Access Report

Carrington Hydraulic
Engine House
Stage 3 Engine Room
Remediation

106 Bourke Street
CARRINGTON NSW

For: EJE Architecture
Ref: LP_21281

Figure 1 | The New Work & Affected Part

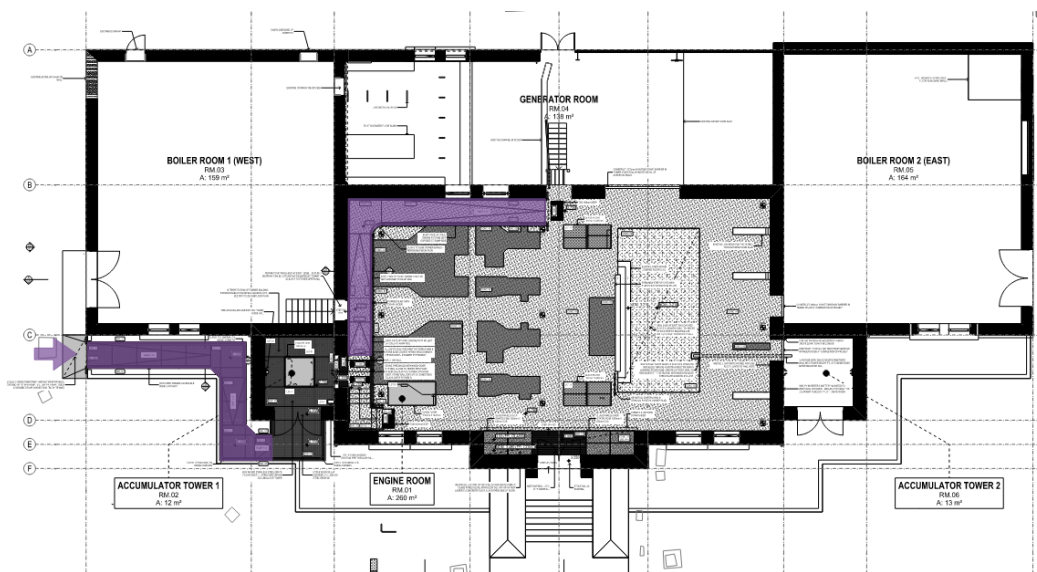
In this instance, the **new work** is the provision of the new floor slab and associated raps and stairs. The **affected part** is the path of travel from the accessible entrance to these areas.

Accessible ramps have been provided within the proposed works to achieve an accessible path of travel from the entry doorway to the new works which is essentially the Engine Room.

Figure 2 | Overall Site Plan

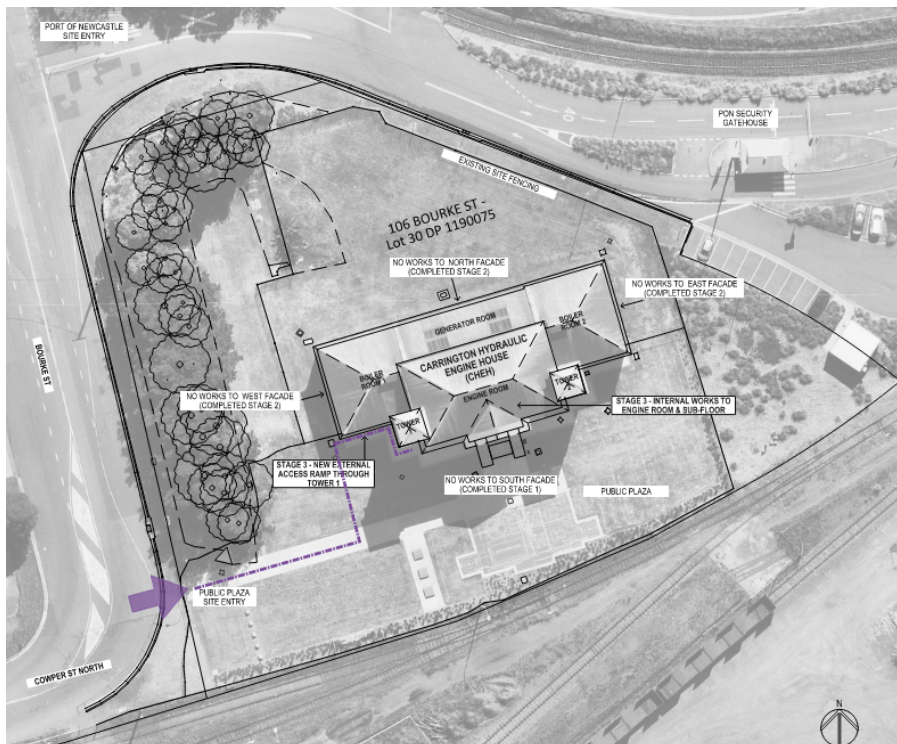
- from the allotment boundary at the pedestrian entrance along Cowper Street North to the accessible building entrance.

A new accessible ramp is provided as a part of the approach to the accessible building entrance.

The accessible ramp is provided in three sections with a 90° change in direction between each section. The overall configuration meets current accessibility requirements – the nominated gradient is 1:14; the clear width of the ramp exceeds 1000mm between handrails; handrails with extensions are provided to both sides; landing offers complying wheelchair turning areas.

The provision of tactile indicators to this ramp is subject to further design as noted in the documentation.

- a. Ramp to comply with AS1428.1, Clause 10.3. Maximum allowable gradient of the ramp is 1:14, minimum clear width to be 1000mm and maximum length between landings to be 9m (for 1:14 gradient).

- b. Accessible ramp is to have a maximum rise of 3.6m (BCA Clause 3.11).
- c. The ramp is required to be set back a minimum 900mm from the property boundary (AS1428.1, Clause 10.3 (f)). This allows tactile indicators and handrail extensions to occur within the boundary and not protrude into the footpath area.

- d. Provide handrails, with extensions, to both sides of the ramp to comply with AS1428.1, Clause 12. Handrails to have an external diameter between 30-50mm to assist persons with a manual disability such as arthritis. Handrails are required on both sides of the ramp to cater for left and right-handed disabilities.

- e. Where ramp is not enclosed, provide kerb rails in accordance with AS1428.1. The height of kerb rails is to be less than 65mm or greater than 150mm above the finished surface level. This is to ensure that the foot plate of a wheelchair cannot become lodged on the kerb rail.

- f. Provide tactile indicators at the top and bottom of the ramps to comply with BCA Clause D3.8 and AS1428.4. Tactile indicators to be detectable, durable, non-slip and have a minimum 30% luminance contrast to the background colour. For discrete tactile indicators, 45% luminance contrast is required (60% where two-tone indicators are used).
